Proposed amendments to Regulation No. 53 for headlamp corresponding to inclination

The modifications to the current text of Regulation No.53 are marked in **bold** characters.

Figure 1. Description of the Function of the Inclination Angle adjustment-Type AFS

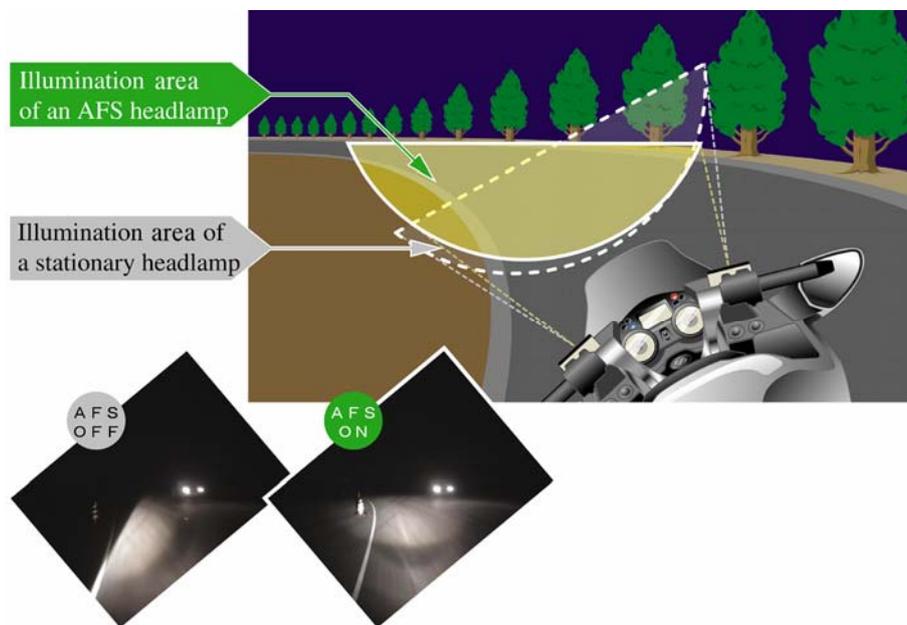
In the case of a motorcycle, due to its driving characteristics, the headlamp inclines with the vehicle when the vehicle is running on a curved road, narrowing the illumination area of the headlamp in the traveling direction. Therefore, by adjusting the variation of the headlamp's light distribution from that when the vehicle is upright, *i. e.*, in the standard condition, to keep the illumination area wide enough, the visibility is expected to improve.
